WeMo Switch V2

CMF AND PRINT GRAPHICS

REVISION: 2.4

DATE: 2016-08-24

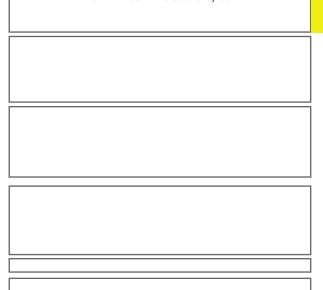
v2.1 - Adjusting certification print graphics to match new sized label recess.

Added FCC/IC ID numbers

v2.2 - Removed UL logo and adjusted layout.

Changed product name to "Mini".

Adjusted placement of Wemo logo on front.

v2.3 - Adjusted front texture to be slightly heavier.

YS-20038 is replaced with YS-20048.

v2.4 - Adjusted copy for Factory restore.
